I hereby give notice that a hearing by commissioners will be held on:

PRIVATE PLAN MODIFICATION 46
HEARING REPORT
MAKETU ROAD, QUARRY ROAD AND
FITZGERALD ROAD
DRURY SOUTH LIMITED

Figure 11: Maketu/Avenue Road intersection alignment proposed through PC46 (A) compared with Mr Collins' recommended alignment (B).

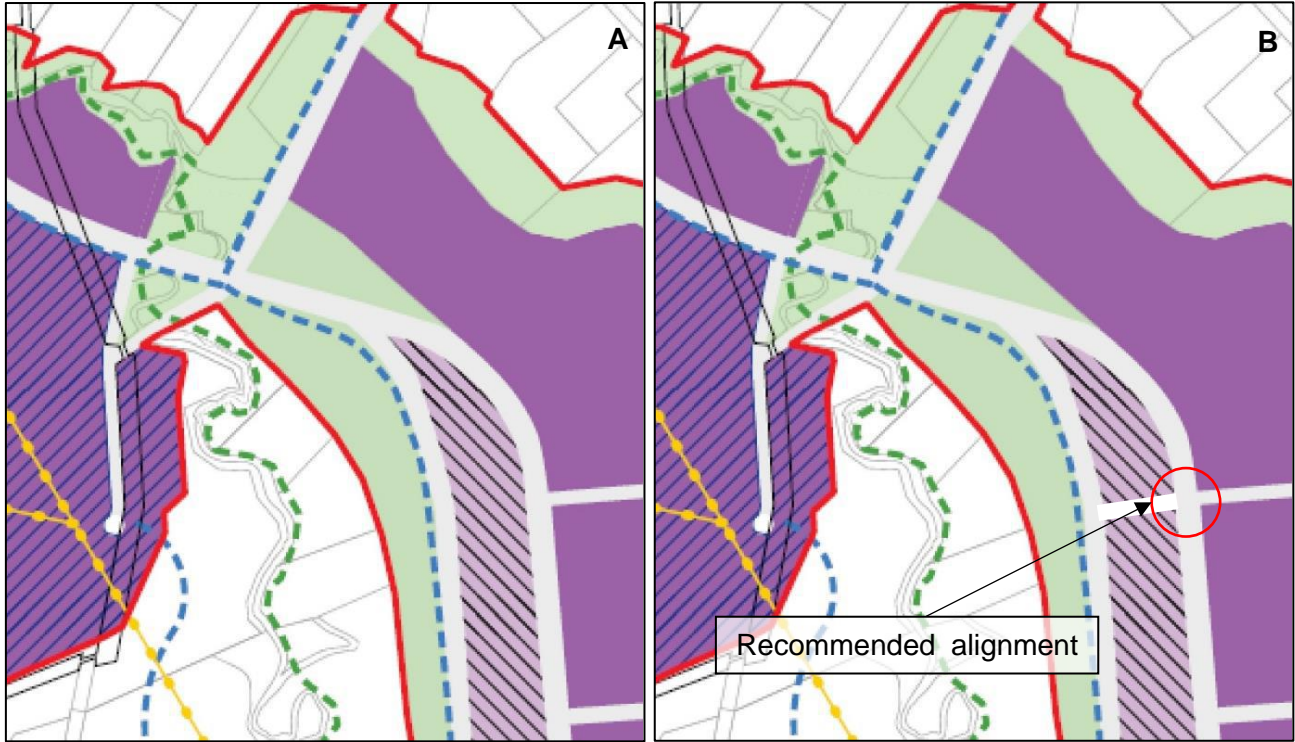
- e) The proposed relocation of the Avenue Road/Maketu Road intersection may create safety and operational issues arising from the acute angle of this proposed intersection and reduced sightlines for vehicles. Mr Collins considers that an alternative alignment connecting Avenue Road with Road 5 and Maketu Road (refer **Figure 11** within Section 10.2.5 of this report) would address these concerns. This alignment would also ensure some separation with the Mill Road corridor.

Mr Collins recommends that Precinct Pan 1 and 2 are amended to show Avenue Road intersecting Maketu Road with proposed Road 5 (refer to **Figure 11** below).

316. DSL, NZTA and AT have discussed the Avenue Road/Maketu Road intersection alignment in their meetings, and have resolved to amend Precinct Plans 1 and 2 to align the intersection with Road 5. This is shown in **Figure 12** below, and is consistent with the Mr Collins's preferred location.

I410.10.2 Dury South Industrial and Mixed Use: Precinct Plan 1

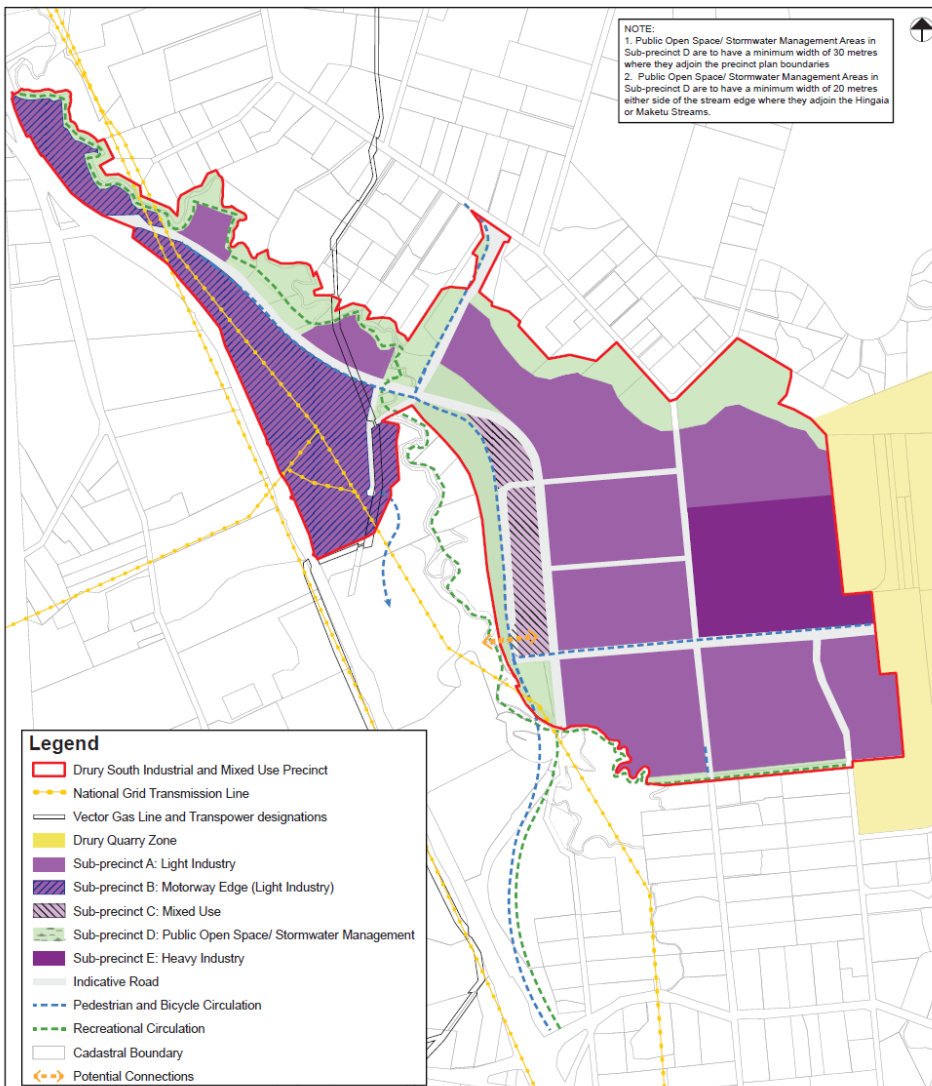
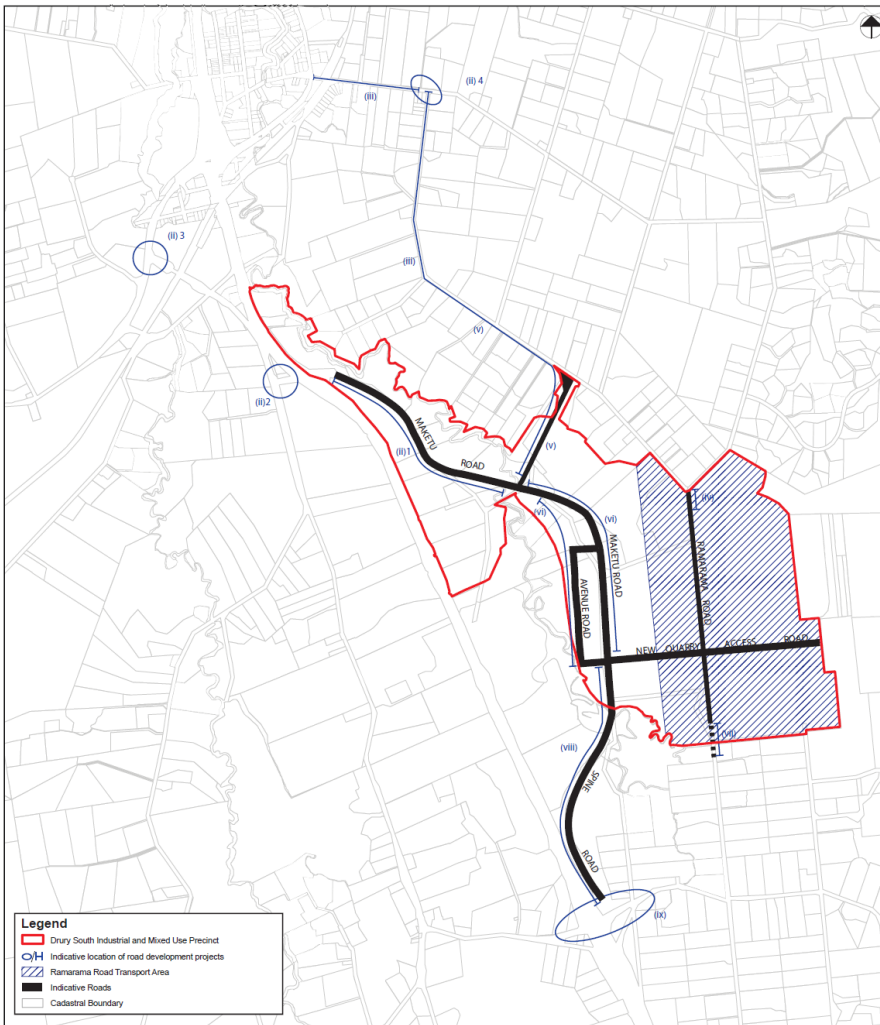
Commented [SB22]: Amended following close of submissions to reflect:

- Realignment of Maketu Road/Avenue Road intersection: NZTA – 2.2 and AT – 5.12
- Ramarama Road remaining open to Fitzgerald Road: AT – 5.13

I410.10.2 Dury South Industrial and Mixed Use: Precinct Plan 1

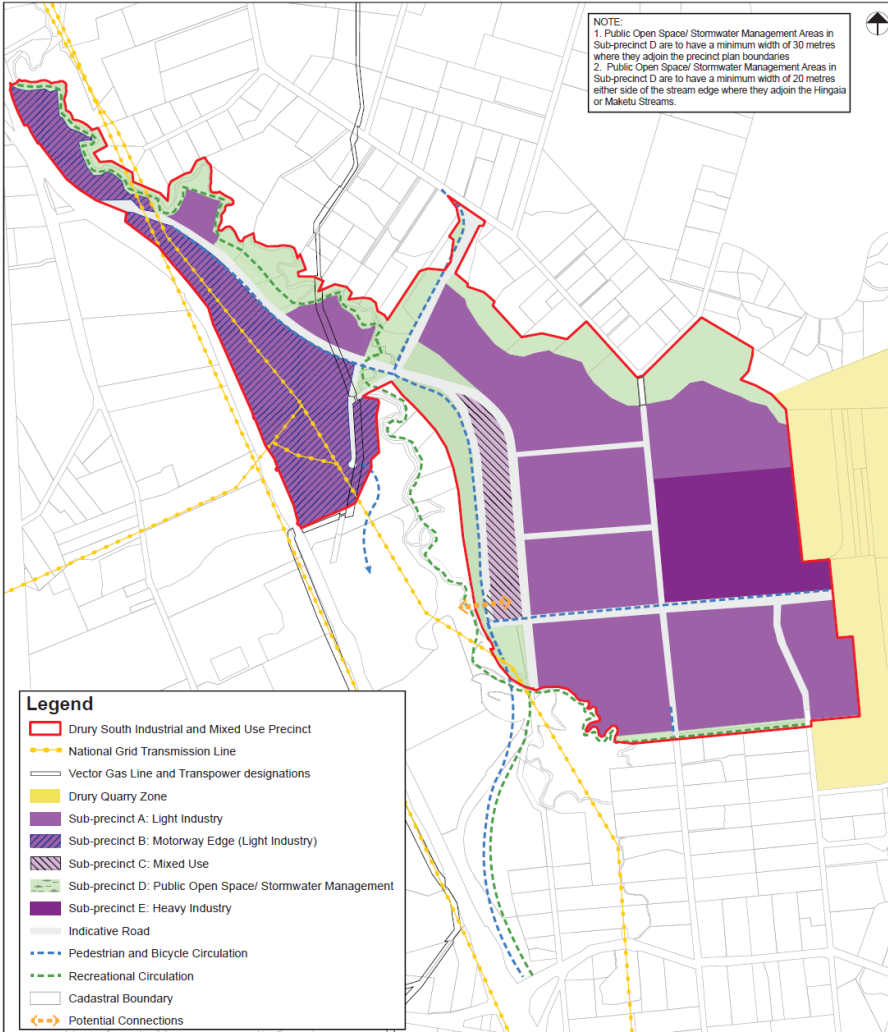
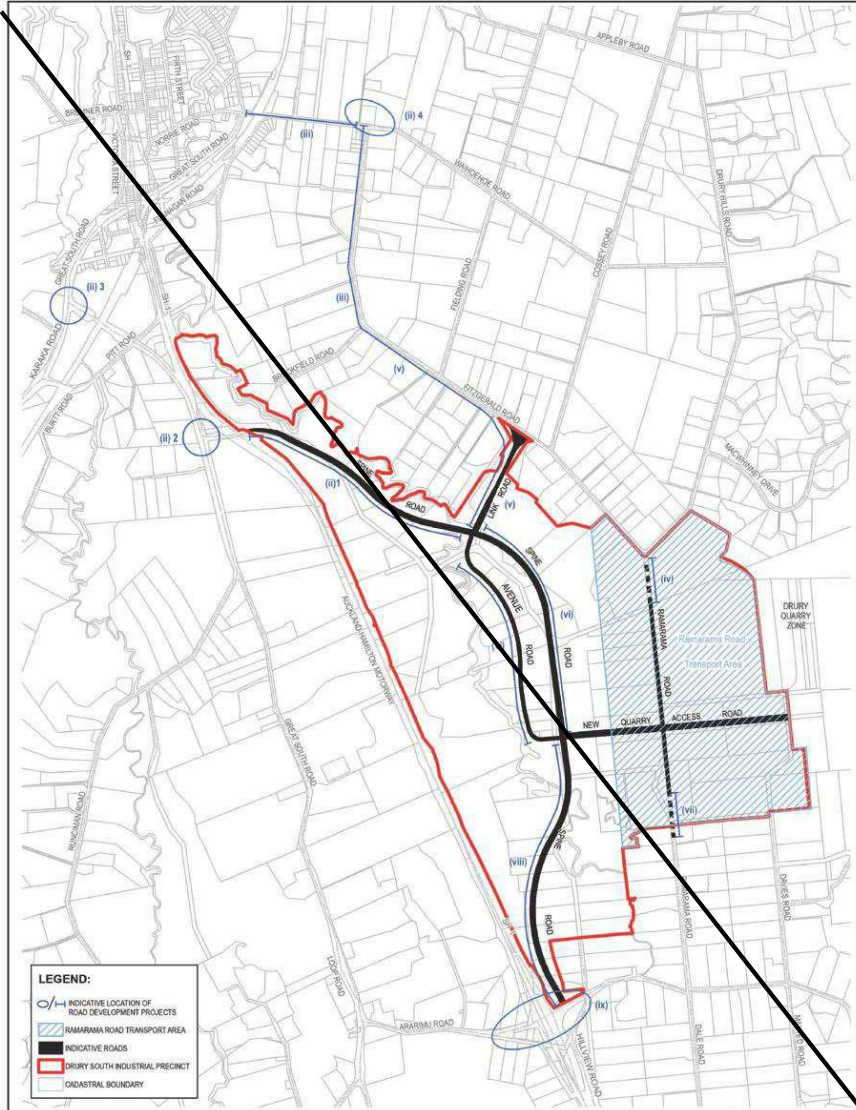
Comment [RM19]: AT/NZTA - amend to show alternative location of avenue road and show the northern end of Ramarama Road remaining open.

Figure 3: Spine Road / Link Road / Avenue Road alignment

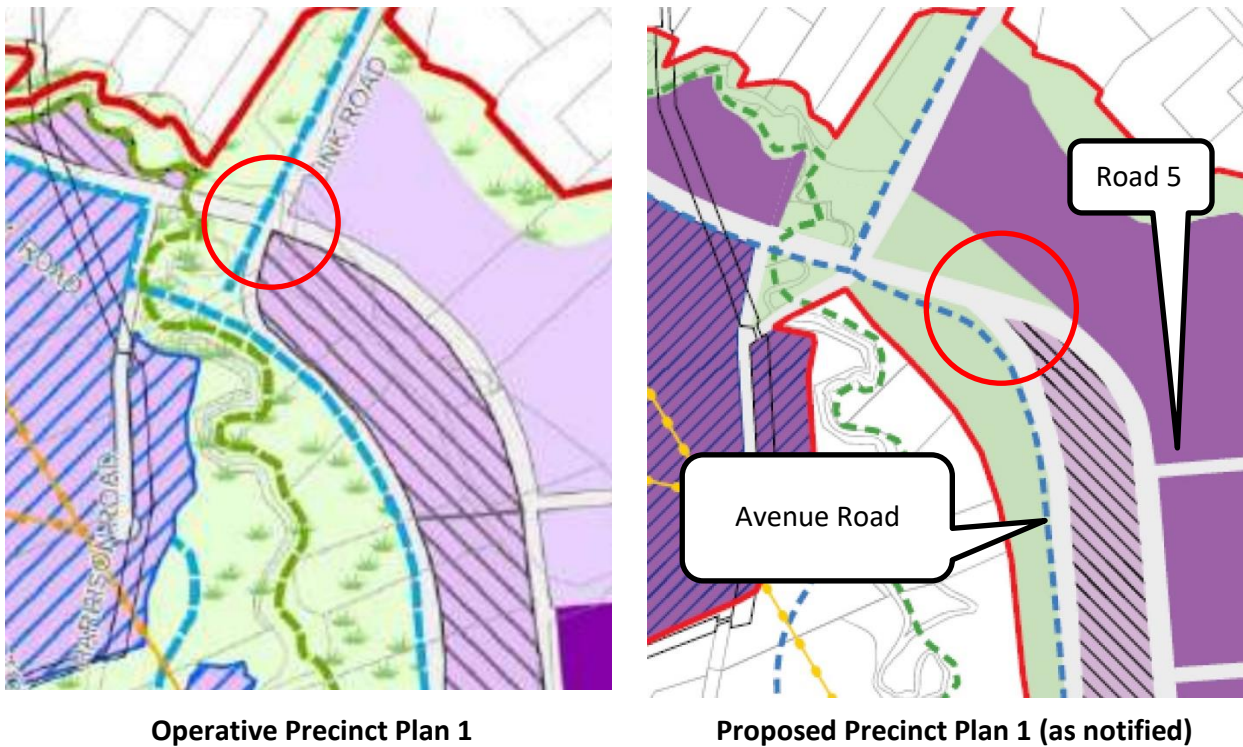
Section 2.1 of the TAR discusses how the intersection of Avenue Road (Road 3) with Link Road may be affected by the Mill Road corridor, which is currently under investigation by the Supporting Growth Alliance. Beca suggests that the northern intersection of Avenue Road may need to be moved south to connect with the east-west road (Road 5). We support this conclusion and associated changes to Standard I410.6.3.(1). Section 3.3 of the TAR discusses how the alignment of the northern Avenue Road has been amended to align with the developable area as shown in Figure 3 (as notified).

Figure 5: Spine Road / Link Road / Avenue Road alignment

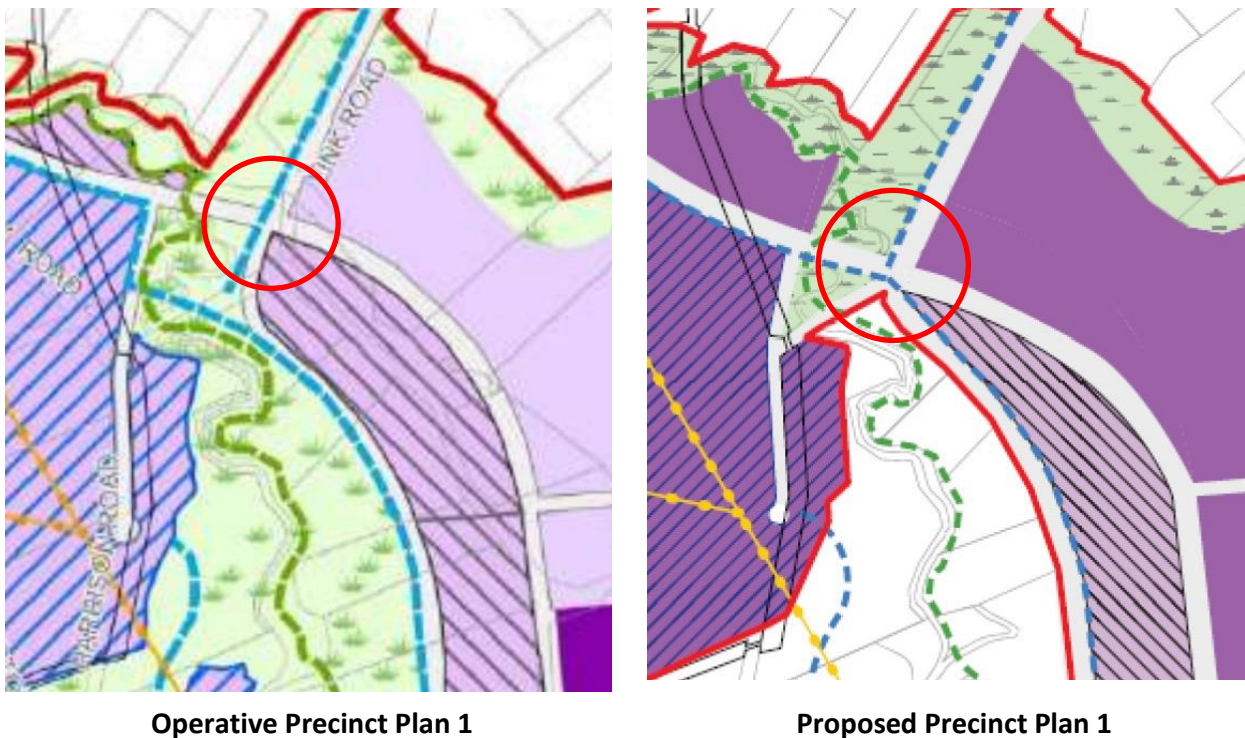
Section 3.3 of the TAR discusses how the alignment of the northern Avenue Road has been amended to align with the developable area. We note that this has resulted in a less than desirable intersection arrangement between Spine Road, Link Road, and Avenue Road, as shown in Figure 5. We consider that the alignment shown in Precinct Plan 1 and Precinct Plan 2 may create safety and operational issues for this intersection.

I410.10.2 Drury South Industrial and Mixed Use: Precinct Plan 1

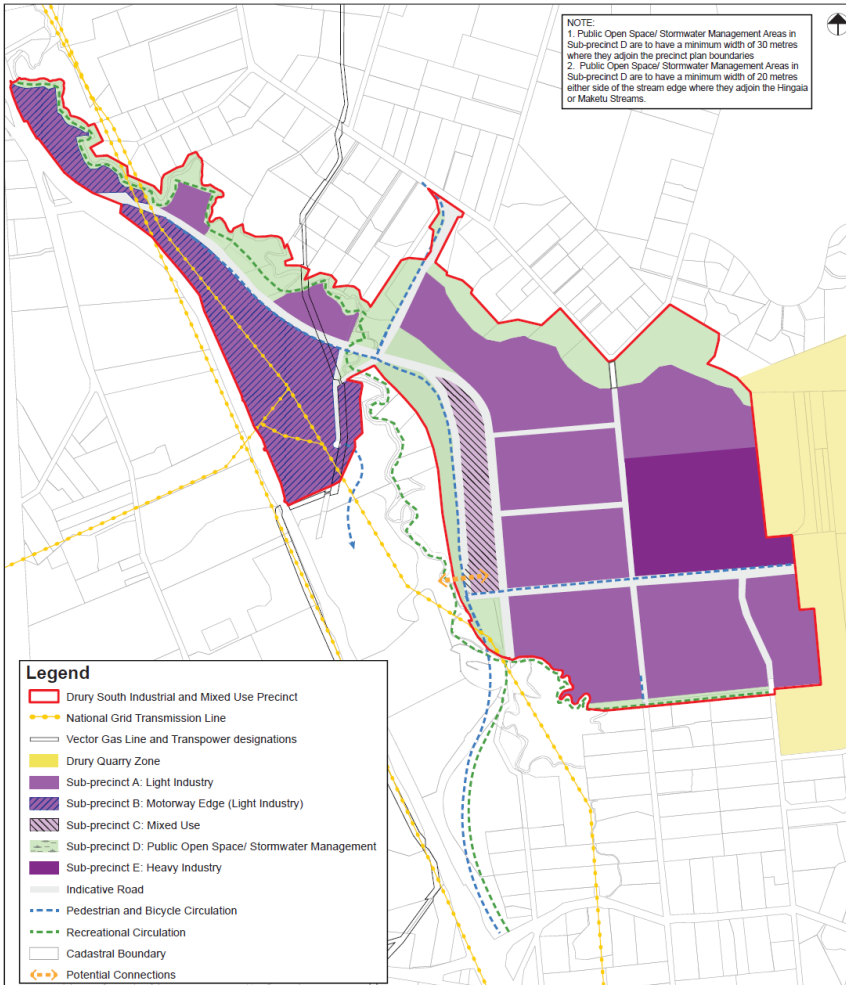
Commented [RM16]: AT/NZTA - amend to show alternative location of avenue road and show the northern end of Ramarama Road remaining open.
